STAFF REPORT: JULY 10, 2024, REGULAR MEETING PREPARED BY: T. BOSCARINO

**APPLICATION NUMBER:** HDC2024-00333

**ADDRESS:** 630 VIRGINIA PARK

SCOPE: ENLARGE DRIVEWAY (WORK COMPLETED WITHOUT APPROVAL)

July 2024 photo by staff showing existing condition and work completed without approval.

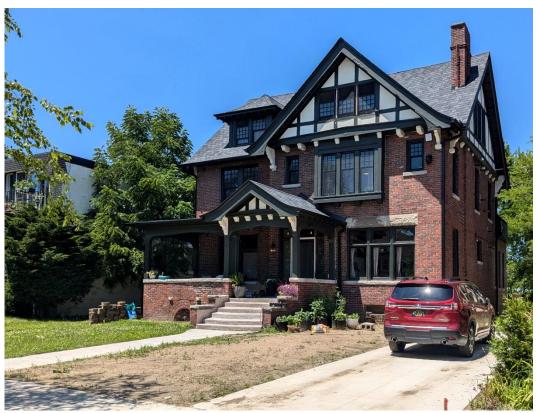
Subject of this application, the driveway has recently been expanded from a narrow, ribbon driveway, to a wider paved surface. This work is completed without approval and is visible on the property. (shown in photos on the next page).

• The proposed (already installed) driveway extends in front of the front façade of the house by about twelve inches. As a driveway is, by definition, a pathway from the street to a rear garage, this additional width effectively creates a paved surface in the front yard of the property. This interferes with the character-defining front lawn and is inappropriate, in staff opinion (thereby precluding administrative approval of the completed work). The work is contrary to the Secretary of the Interior's Standards for Rehabilitation, namely Standard #2: "The historic character of a property shall be retained and preserved. The removal of historic materials or alteration of features and spaces that characterize a property shall be avoided."

- The proposed (already installed) driveway shall be reduced in width by approximately twelve inches to avoid overlapping the front façade of the house.
- The walkway leading to the door shall not be altered from its existing footprint.
